Completed Projects / Projets terminés

Formal Interpretations

The following interpretation regarding Clause 4.14 of CSA standard **Z662-03**, *Oil and Gas Pipeline Systems*, has been approved by the Technical Committee on Oil and Gas Pipeline Systems and Materials.

FIGURE 1: LINEAR AND BRANCHED CONNECTIONS

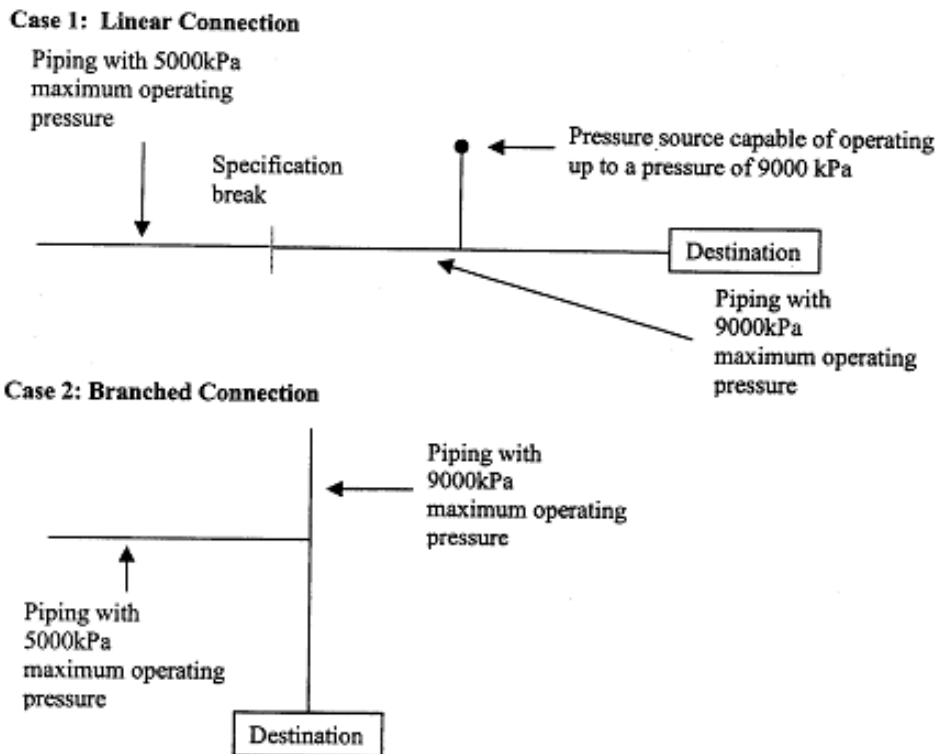
Question 1: Where piping is connected to downstream piping that could operate at a higher maximum operating pressure than the connecting piping, can a check valve be used as a pressure control system to satisfy the intent of Clause 4.14.1.1? The attached Figure 1 illustrates two cases. The first is a linear connection, the second a branched connection. Please answer for both cases.

Question 2: Where piping is connected to downstream piping that could operate at higher maximum operating pressure than the connecting piping, can a check valve be used for over pressure protection to satisfy the intent of clause 4.14.1.2? The attached Figure 1 illustrates two cases. The first is a liner connection, the second a branched connection. Please answer for both cases.

Answer: No (for both cases).

Answer: No (for both cases).

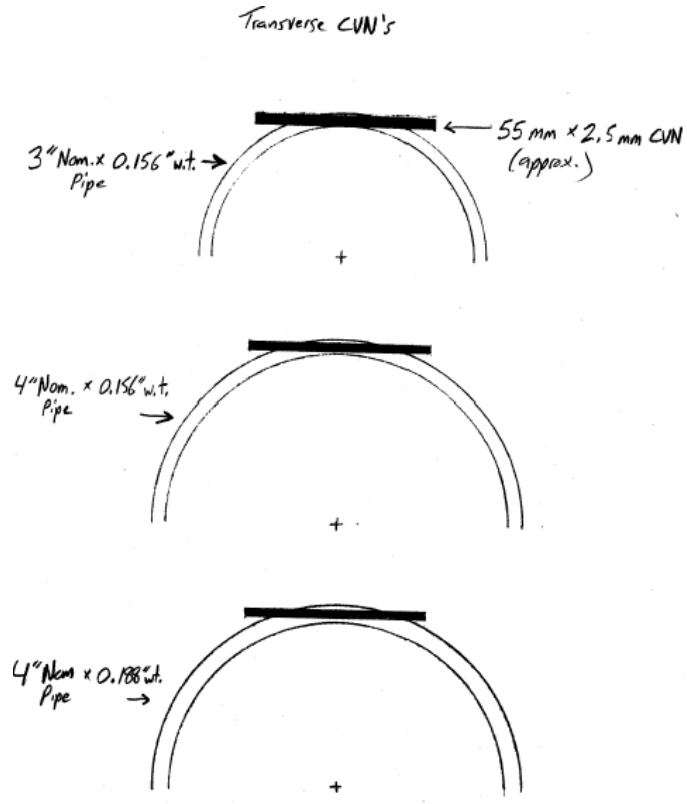
Question: When traverse Charpy impact test specimens (CVN's) are required by the Standard (i.e. on Grades 290 and higher), but the physical dimensions of the test specimens (specifically, 4" nominal pipe and lower) do not allow for removal of transverse specimens (see attached drawing), does the standard permit:

- a) Deletion of the CVN requirements if it is not physically possible to remove them in the required orientation?

- b) Removal the CVN's in the longitudinal direction?

- c) Flattening the test samples to allow for the machining of transverse CVN test specimens?

Answer: Yes, if it is not possible to obtain a 1/4 or larger size specimen.

Answer: No.

Answer: No.
